# Fashion Knits

Latitude: [ 31.441207 ], longitude: [ 73.120085 ]
Date of inspection: 11-Mar-2026

# Fire Safety Inspection Report

# Pakistan Accord Initial Safety Inspection Report

Figure 1.3. Egress layout- Ground floor

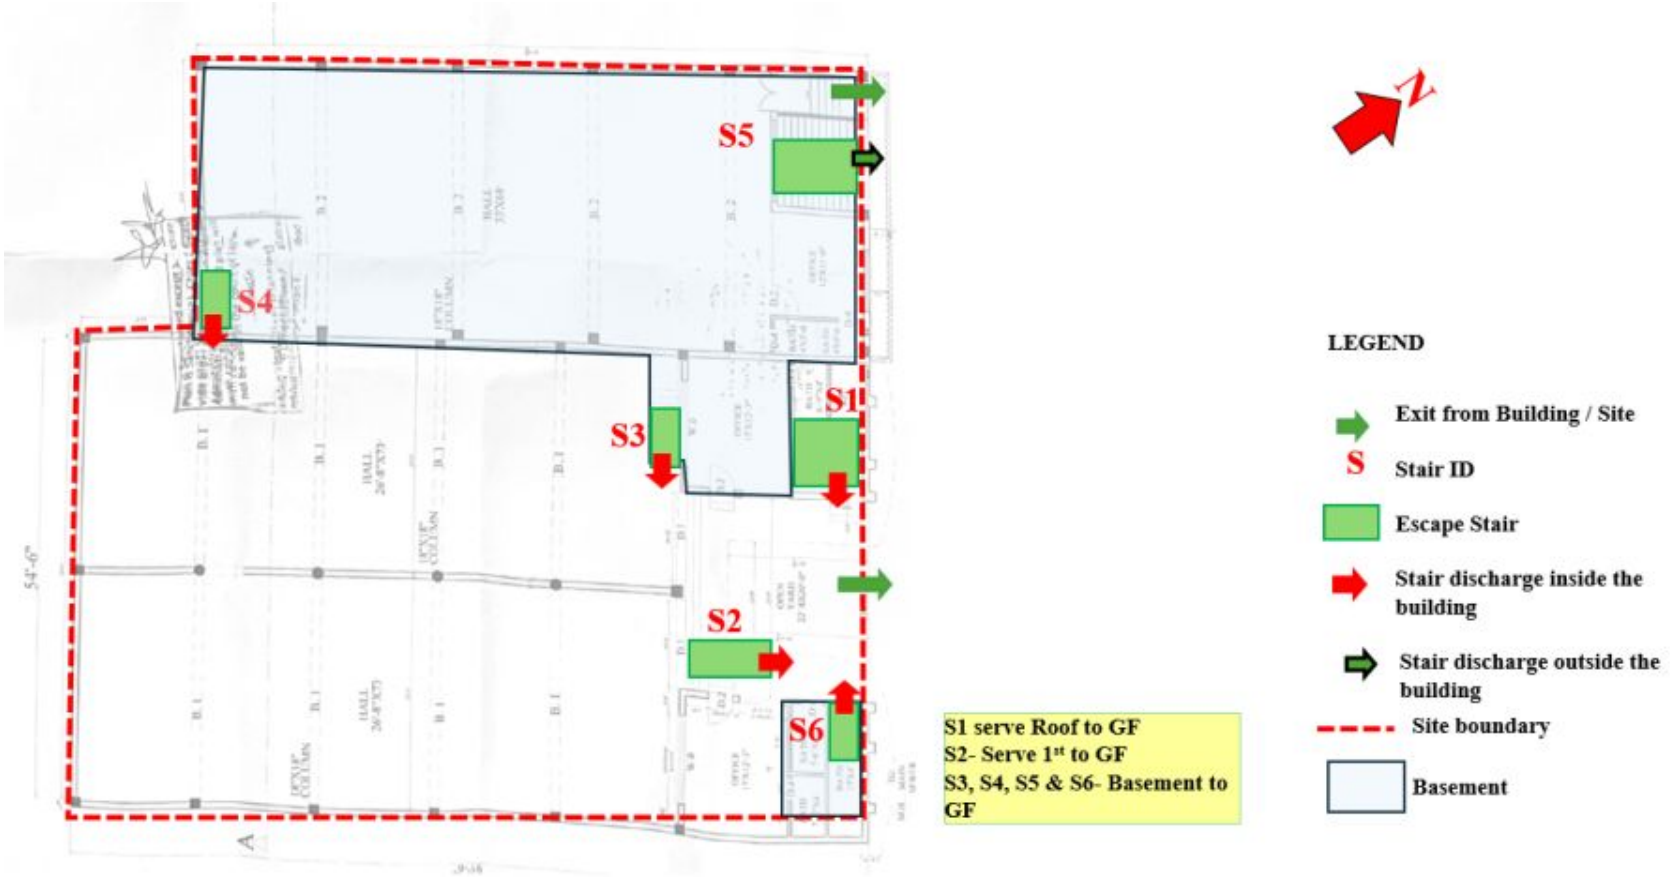
The number of exits are not sufficient first floor (since stair S1 & S2 do not meet the remoteness criteria and taken as single exit).

This is not always achieved, examples include (list not exhaustive):
- Exits via S1 & S2 from 1st floor do not meet the remoteness criteria and considered as single exit.

| Timeline | Remediation Plan |
|---|---|
| Medium Term<br>CAP-0076164 | Review each floor and area to ensure that the number of exits complies with Pakistan Accord Standard.<br>Develop plans and drawings to provide additional exits where necessary. Submit the plan and drawings to Pakistan Accord for review and approval prior to commencing rectification works. |
| Longer Term<br>CAP-0076165 | Implement the above plan as agreed with Pakistan Accord.<br>Number of exits from all floors and parts of the building should comply with Pakistan Accord Standard. |
